ENTECH
ENGINEERING, INC.

WASTEWATER STUDY

**VICINITY MAP
DAVIS RD. & CURTIS RD.
COLORADO SPRINGS, CO.
FOR: U.P.E.**

DEVELOPMENT PLAN/ PERCOLATION TEST
LOCATION PLAN
CIRTUS RD. & DAVIS RD.
EL PASO COUNTY, COLORADO
FOR: UPE

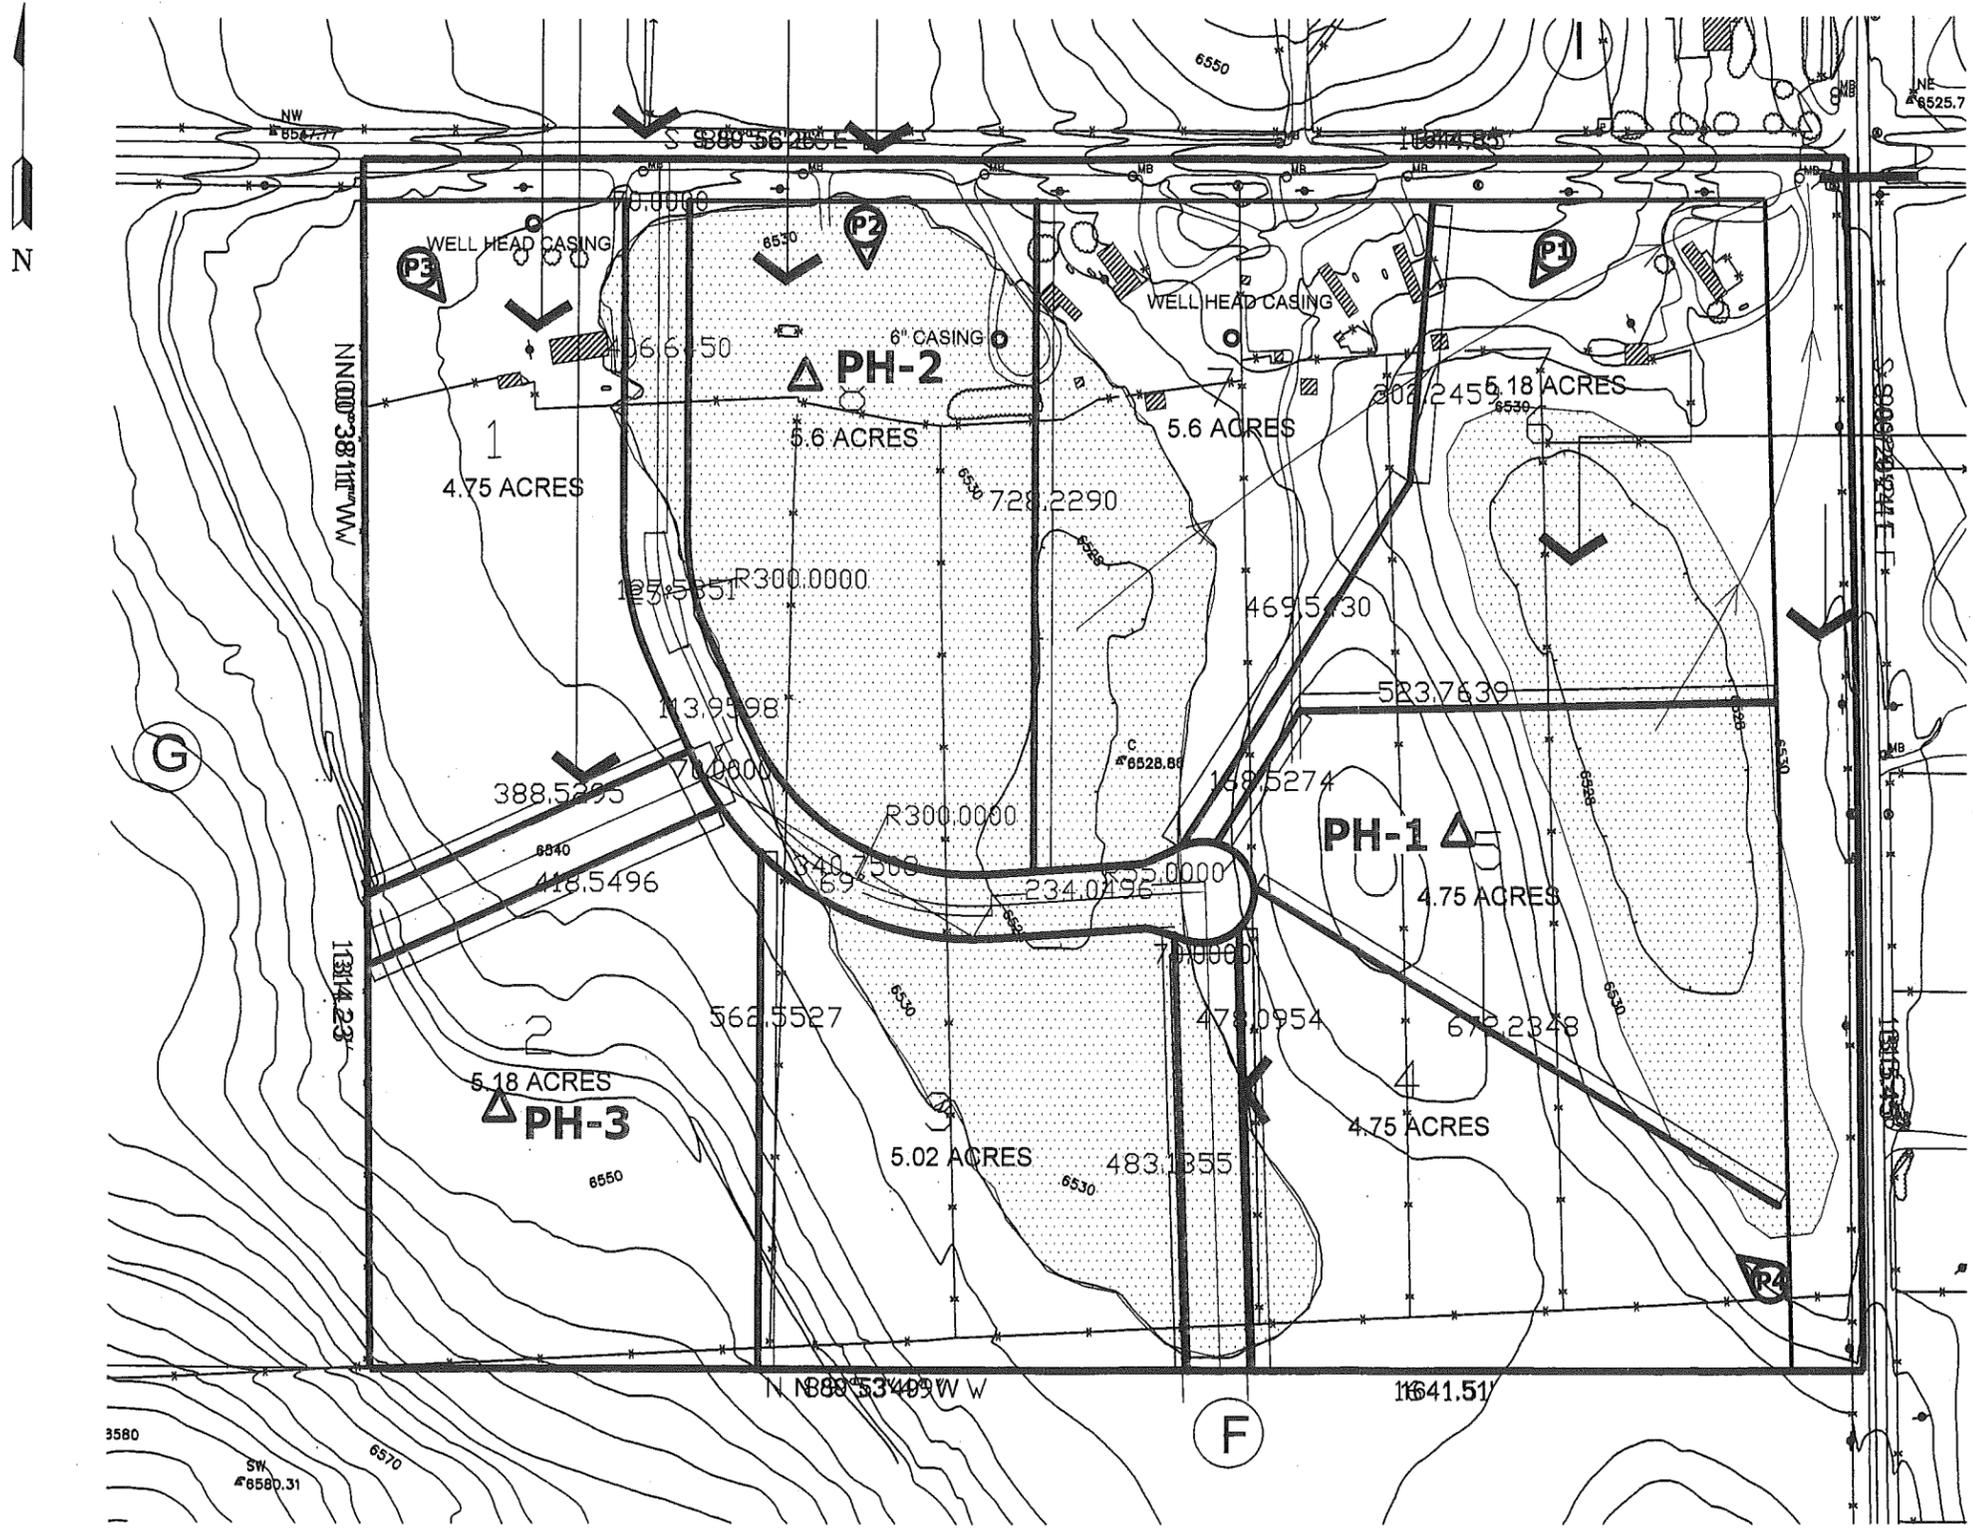
Update to provide additional borings per ECM Appendix C Section C.3.3.B.

Only three borings were performed on the 49 acre development. There should be a minimum of 5 borings.

Also the boring depth does not meet criteria in ECM Appendix C Section C.3.3.D
